**Subject:** RE: CMTD2100698/SYH - OD \_ CLAIM \_ SLM3239Z \_ DOA 04.03.2021- OWN

DAMAGED (TYRE BOLD)

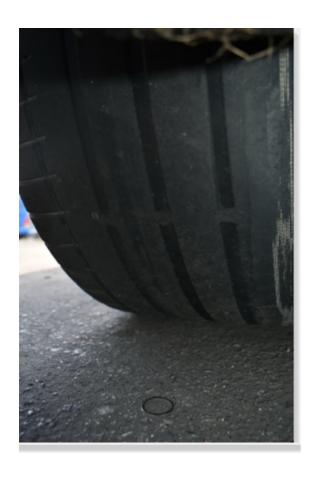
Please let us have the photographs for the measurement for 4 tyres depth and please advise LTA legally requires tyres depth.

Attached herewith the photographs provided by our in house surveyor to shows the tyre excessive wear.

The condition of the rear left tyre does not comply with the legal requirement even though there is still some tread depth left. This is because the inner cords of the tyre were slightly exposed at the inner tread area due to rubber wear.

This does not comply with SECTION 109(e) CAP 276 of THE MOTOR VEHICLES (CONSTRUCTION AND USE) RULES, 1974, 1978 OF THE ROAD TRAFFIC ACT. Under this section it states that "no person shall use, or cause or permit to be used on a road any motor vehicle or trailer, a wheel of which is fitted with a pneumatic tyre where the tyre has any portion of the ply or cord structure exposed".

I note that this is a front to rear collsion where insured vehicle was not able to stop in time. Weather was fine and road surface was dry. During braking, the brake force distrubution is 60% at front wheels and 40% at rear wheels. Any contribution to the accident by the condition of the rear left tyre would be minimal, at best (20% of brake force at rear left wheel). Other factors like driver alertness, distance between front car, travelling speed amongst others would also have to be considered.
